Interim Technical Report

DIABLO CANYON UNIT 1
INDEPENDENT DESIGN VERIFICATION PROGRAM
SOILS REPORT - INTAKE STRUCTURE
SLIDING RESISTANCE
ITR # 40
REVISION 0

Docket No. 50-275
License No. DPR-76

Figure 3
Intake Structure Foundation
Plan View

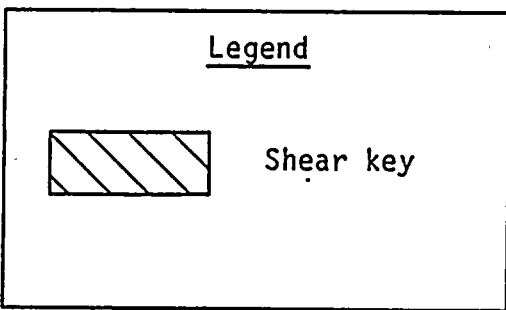
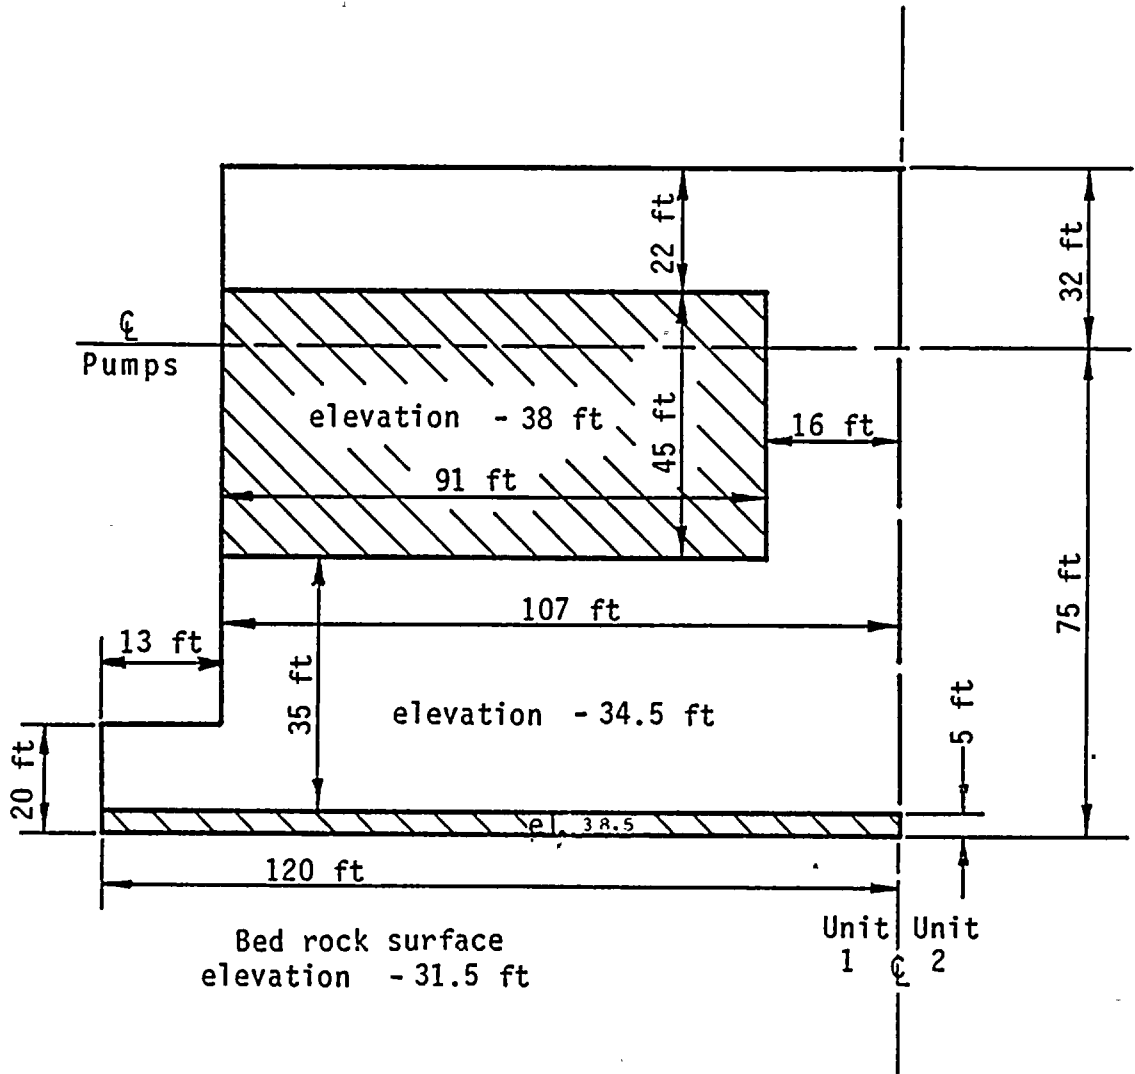
In 1978, Harding Lawson Associates (HLA) determined the postulated sliding surface and resistance factors for the intake building (References 8 and 9). Postulated sliding surface was defined as shearing action through the bedrock between the two shear keys (see Figures 3 and 4). Resistance factors included:

Figure 3 shows the interface between the intake structure and the bedrock which the IDVP determined by reviewing the concrete lift-pour drawings. The IDVP postulated the sliding surface shown in Figure 4.

1. The IDVP accounted for the resistive action west of the outboard key as shear along a 2 to 1 horizontal to vertical slope. HLA accounted for this action by calculating (2) times cohesion (c).

Figure 4
 Intake Structure
 Foundation Profile A-A

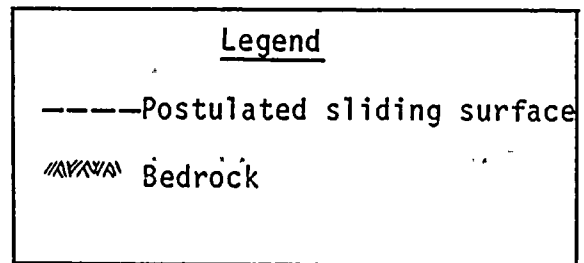
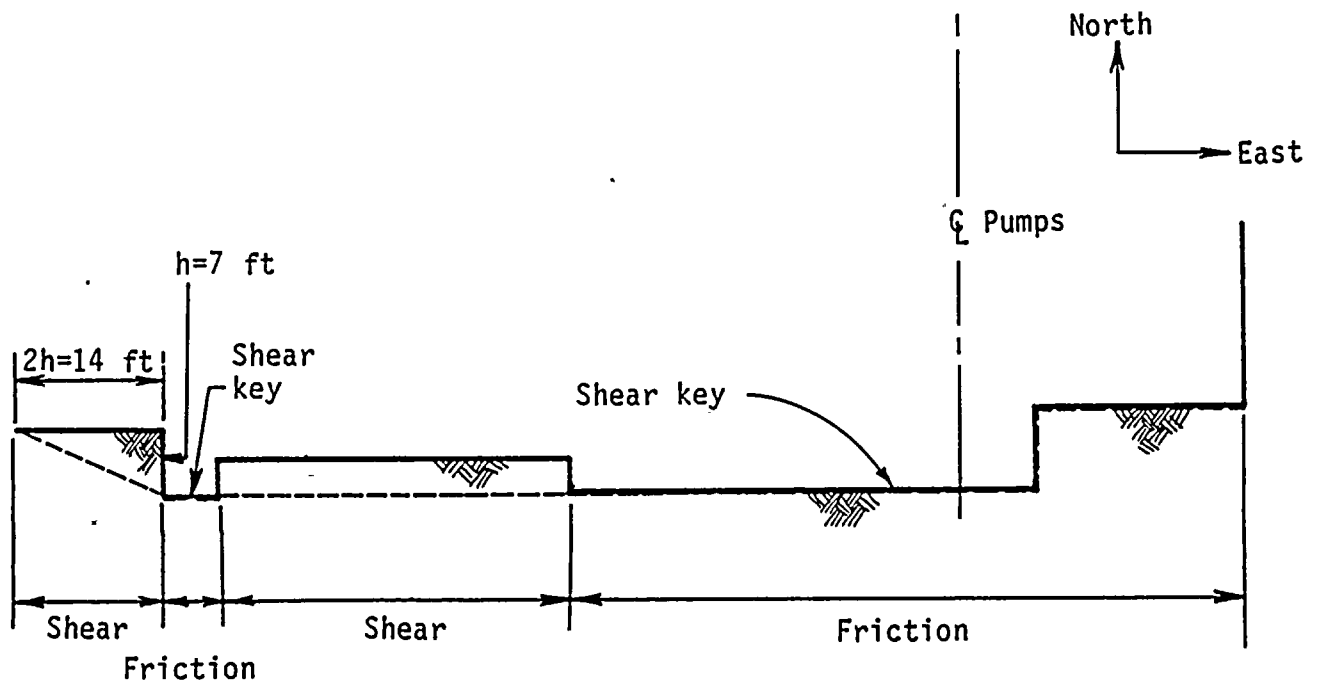
HLA	IDVP
2 (c) h	$c \sqrt{h^2 + (2h)^2}$
2 (3ksf) 7 ft	3 ksf (15.7 ft)
= 42 k/ft	= 47 k/ft

$$c = 3 \text{ ksf}$$
$$h = 7 \text{ ft (see Figure 4)}$$

The differences in the HLA and IDVP results have been examined. As shown previously, the HLA results for cases 1 and 2 produce smaller (conservative) resistive forces. While the HLA results did not explicitly specify a bouyant structural weight, the IDVP determined that it was considered in a subsequent design analysis. Therefore, this difference had no impact.
